Bryant Development and Review Committee Meeting

3. Hillcrest Addition Subdivision - 3927 Springhill Road

Tim Lemons - Requesting Recommendation for Preliminary Plat Approval

Please accept this letter in response to your latest comments as provided in an email on October 22, 2024. I will address the items in the order expressed (my response is shown in ***bold italicized***):

STREET PLAN/PROFILE
HILLCREST ADDITION
PART OF THE SE 1/4 OF SECTION 17, T-1-S, R-14-W
CITY OF BRYANT, SALINE COUNTY, ARKANSAS

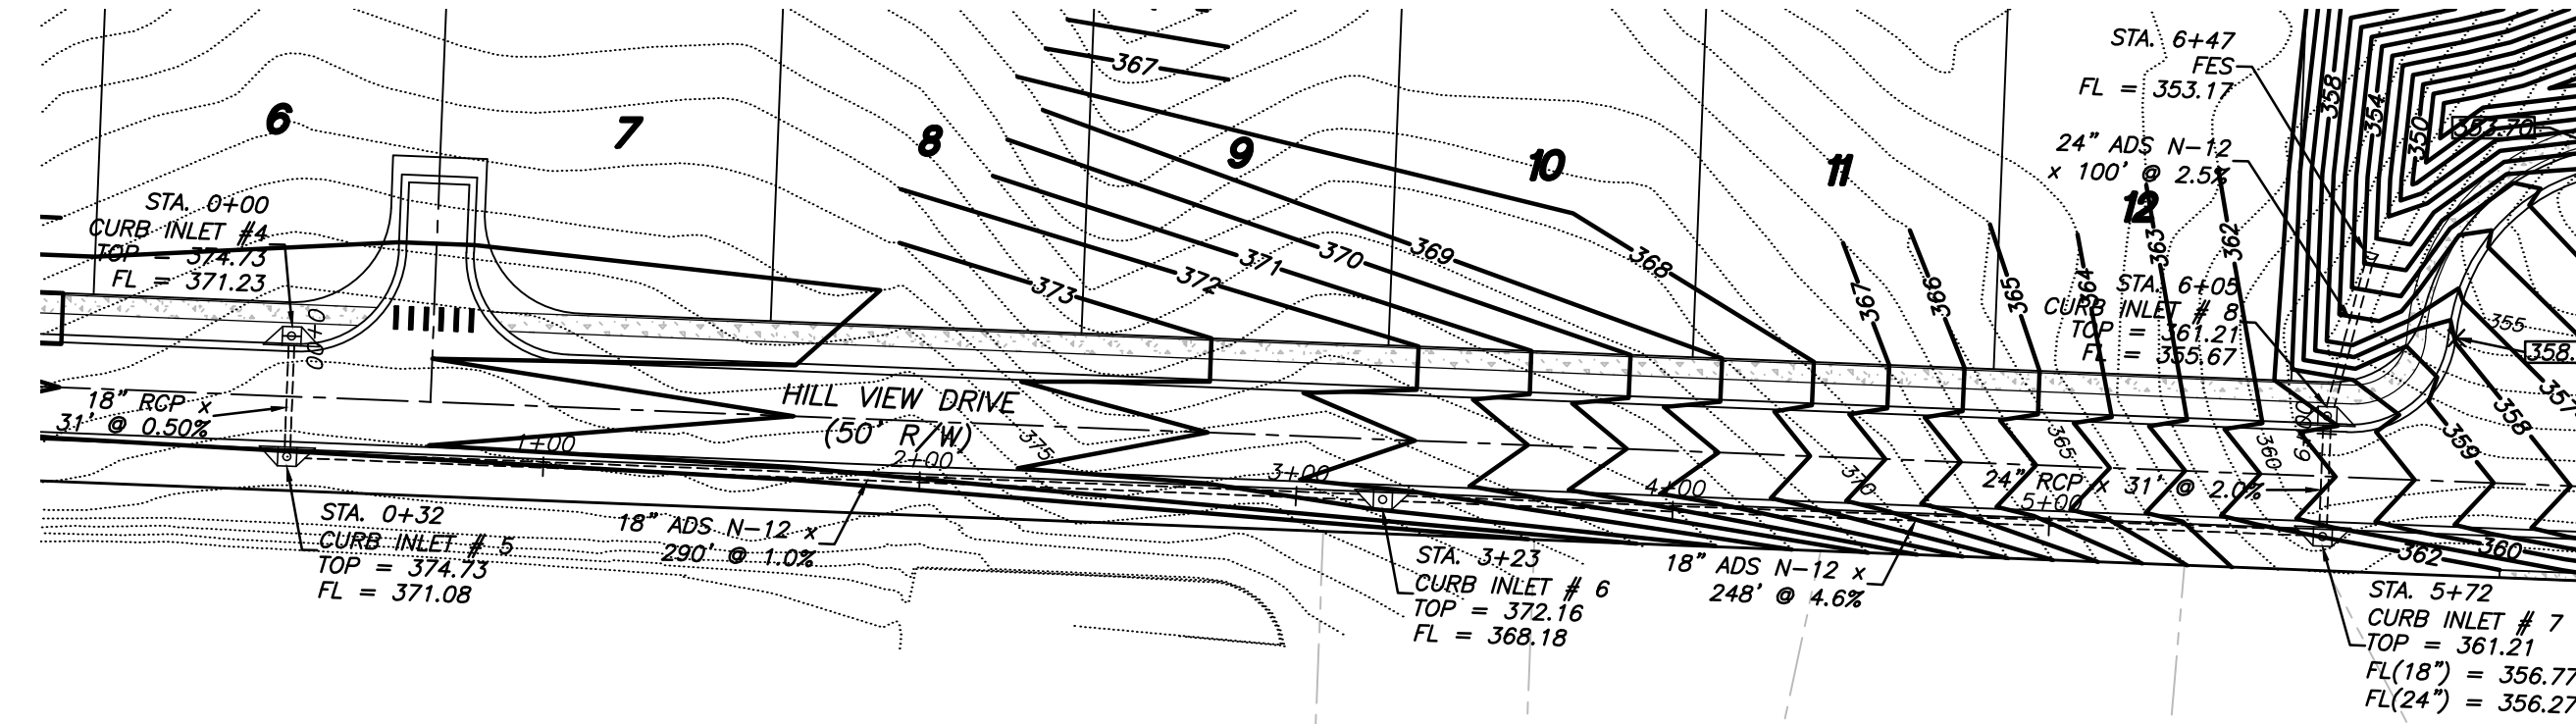
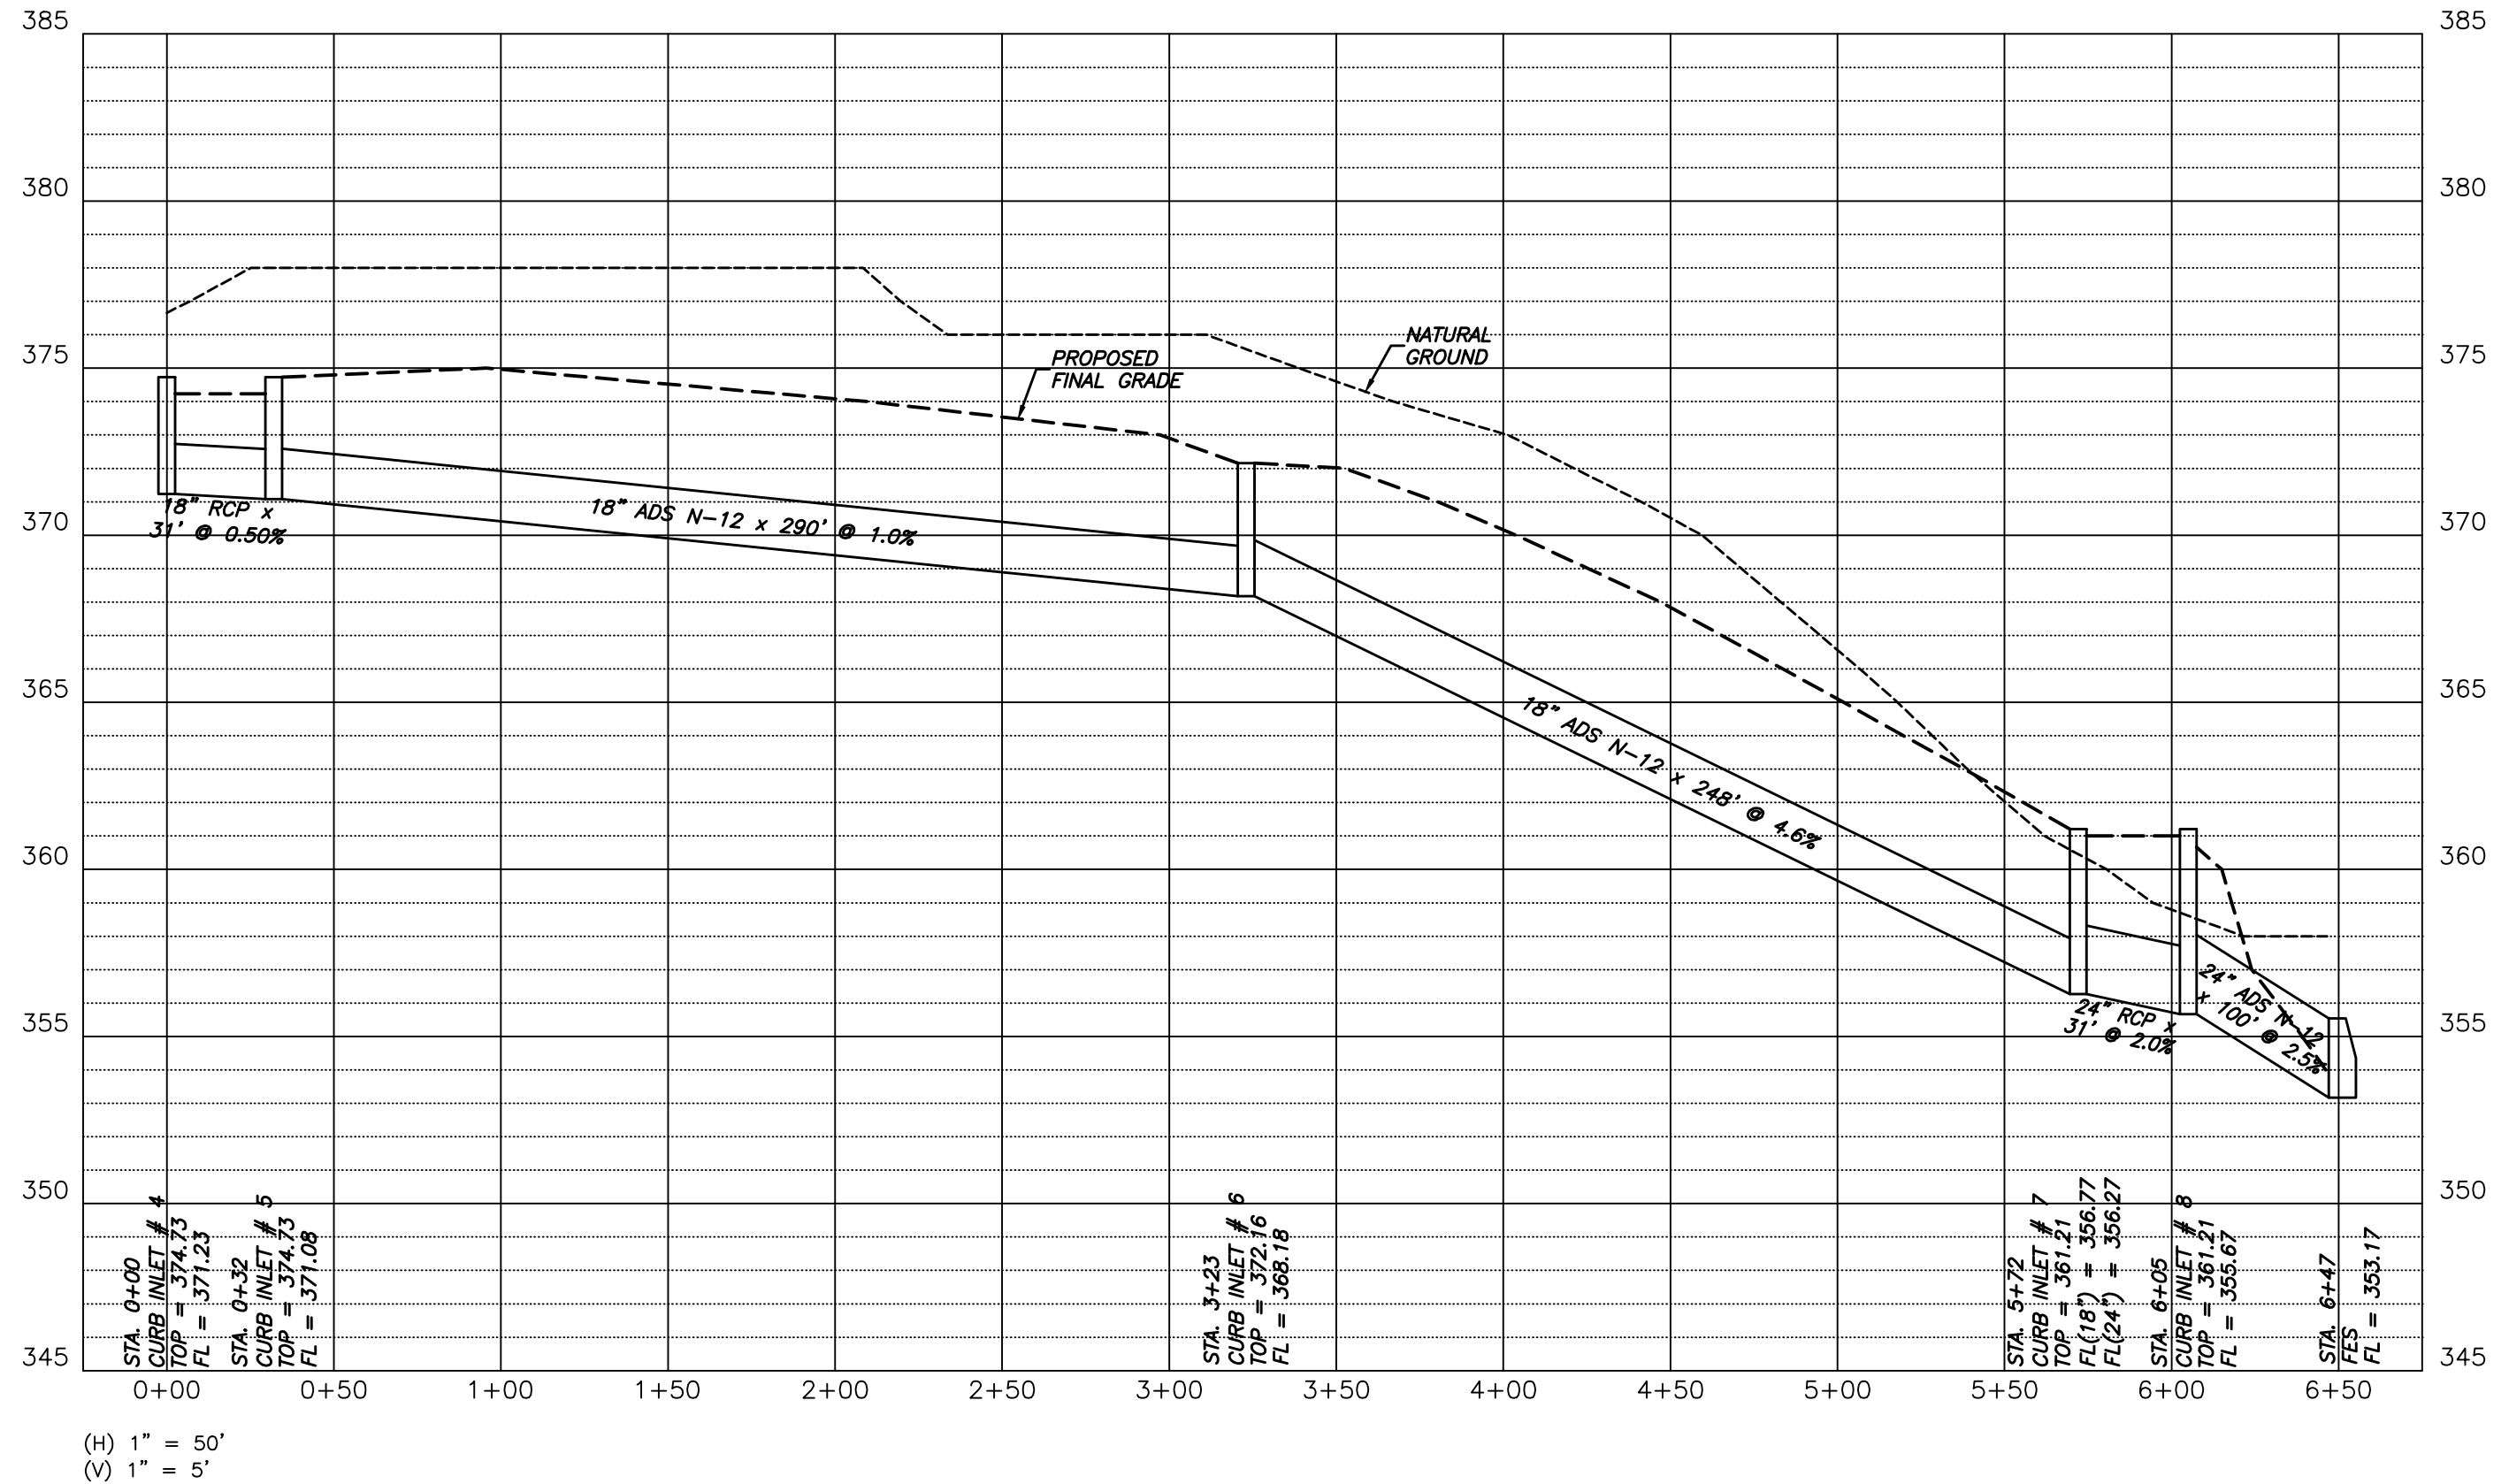
3. 0890-PLN-02.PDF
 - a. On sheet 1, some of the lot dimensions are obscured on the drawing. **This has been revised.**
 - b. On sheet 2:
 - i. the curb and gutter detail does not match the detail show in the City of Bryant's standard curb and gutter section, Detail 7; **This has been revised.**

- ii. The typical street section does not match Detail 1 of the City of Bryant's typical section for Local 1 / Residential Streets; **This has been revised.**

CULVERT PLAN/PROFILE
HILLCREST ADDITION
 PART OF THE SE 1/4 OF SECTION 17, T-1-S, R-14-W
 CITY OF BRYANT, SALINE COUNTY, ARKANSAS

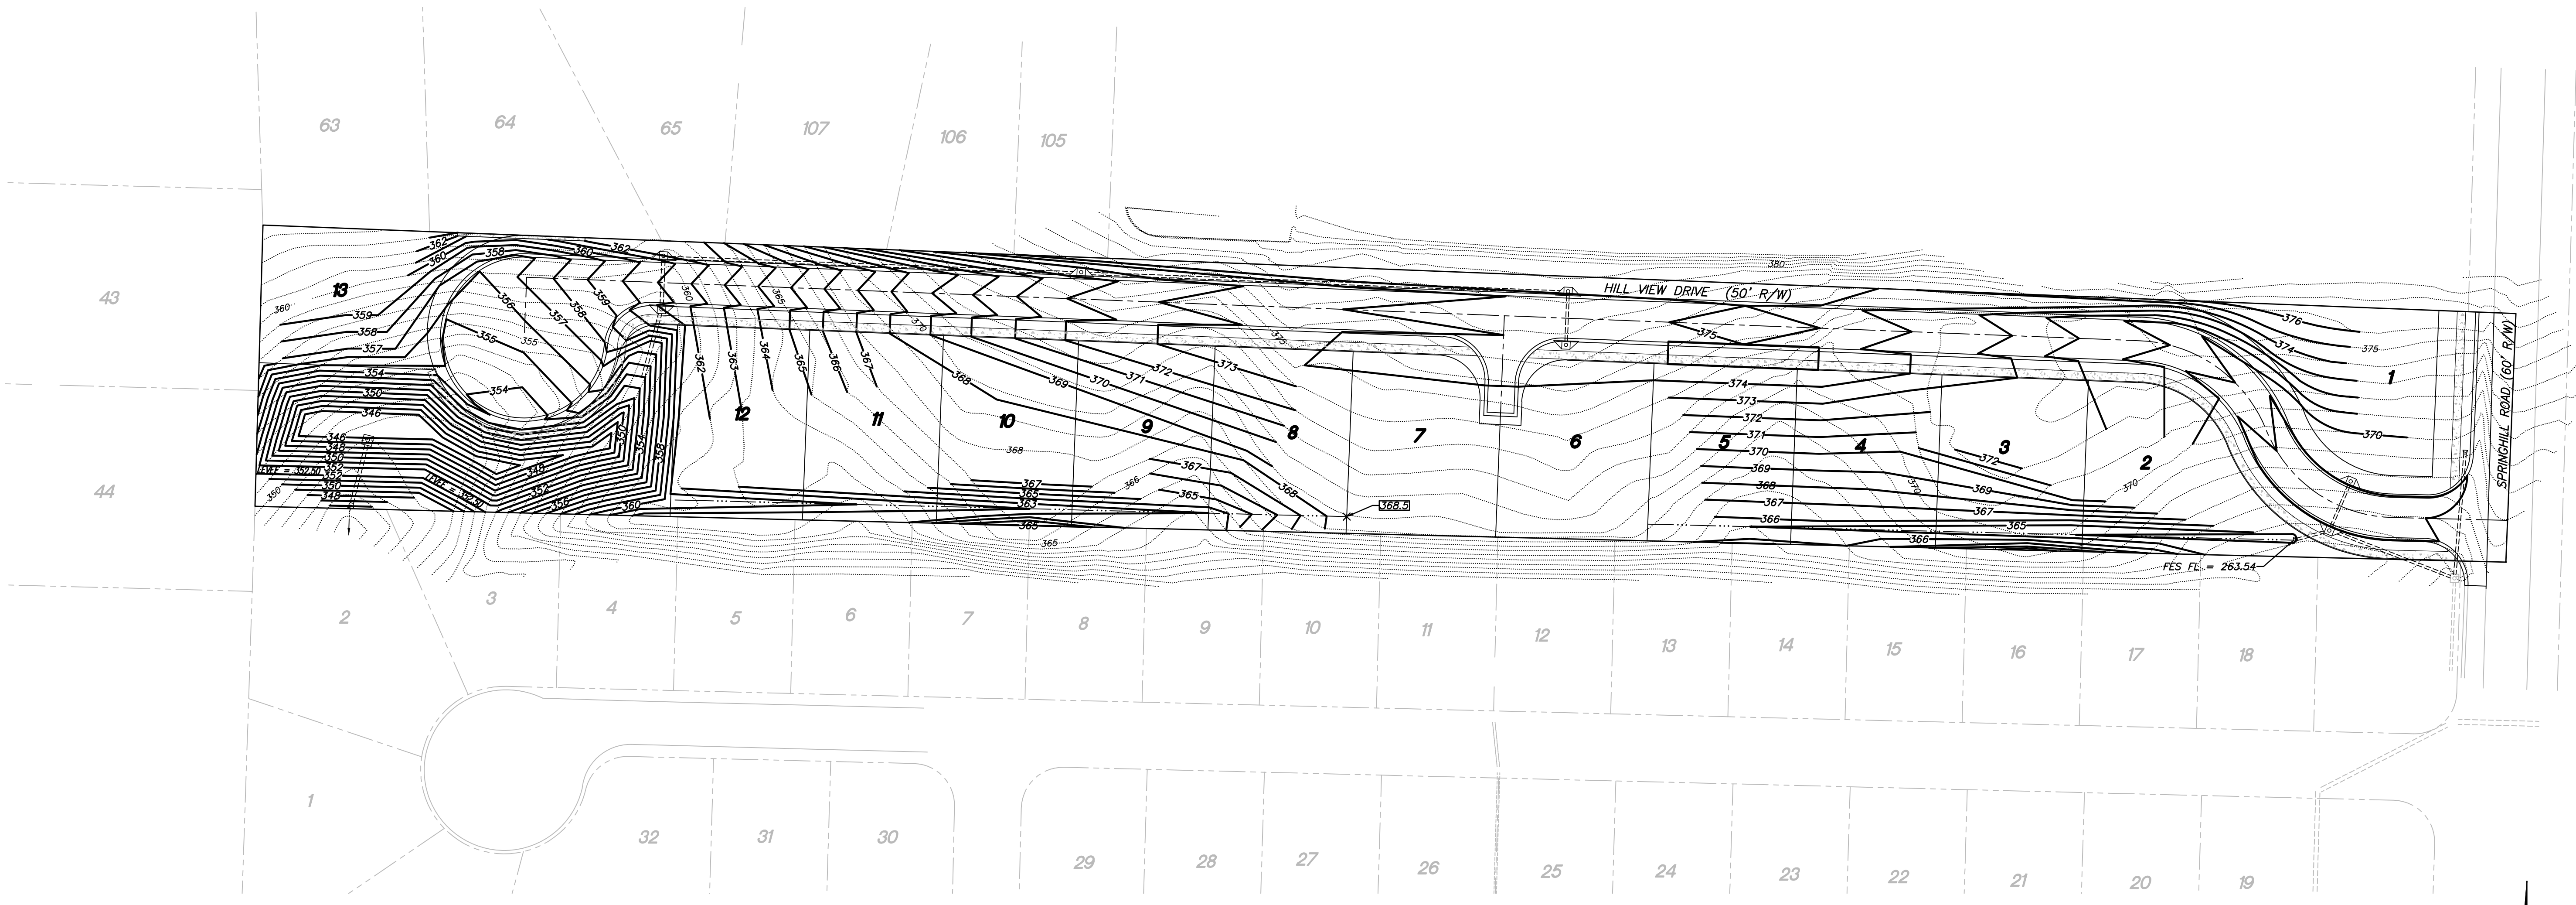
1. Sheet 3 of 10 shows the existing 18" culvert stopping just behind the curb of the half-street improvements. Since the existing ditch will be graded over, it appears that this pipe should be extended to the north and pick up flow from the north. ***We will need to consult the owners as to when the half street improvements will be constructed. If the City and the Owner agree to an in leu of cost clause, the pipe will need to end in the vicinity of where it is shown on the existing plans. We are willing to discuss this with staff.***

2. Sheet 3 of 10, show the existing ditch & culvert to the south of JB#3 along Springhill Road. Show details on how the outlet looks and how the flow will be handled to the south. ***We will be matching the existing half street road improvements from our planned intersection, to the South. This has been added to this sheet.***
